# INITIAL FIRE SAFETY INSPECTION REPORT

**Indochine Apparel (Bangladesh) Limited, Plot 54-56 (Previously Baxter  
Brenton (BD) Clothing Manufacturing Co. Ltd (Extension)**

**RSC ID: 25854**

**Date: 09-September-2025**

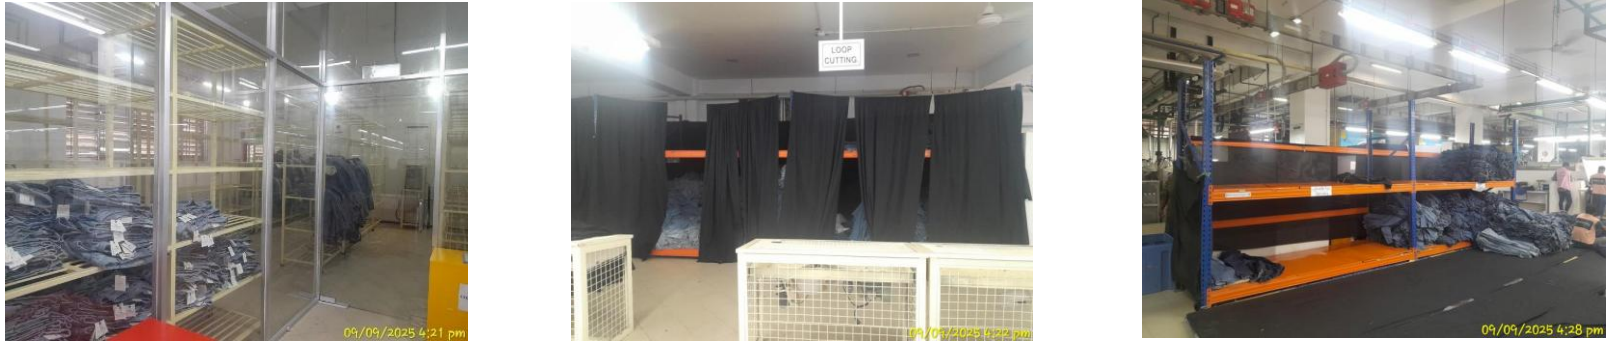
| F-11                                                                               | Means of Egress | <p>Changes in level was found 24 in. where RSC Technical Guidelines (Standard)<sup>1</sup> V1.0 Section 6.9 or 6.10 doesn't meet.</p> <p><b>Location: Exit stair-1, 2 &amp; 3 at the ground floor of Building 1.</b></p> <p>Non-Compliance Reason: Handrails not provided.</p> | <p>Changes in level exceeding 535 mm (21 in.) in elevation shall meet the requirements for stairs in 6.9 or ramps in 6.10. The change in level shall be readily apparent and if not, marked with additional signage or floor markings.</p> | Within 3 Months |
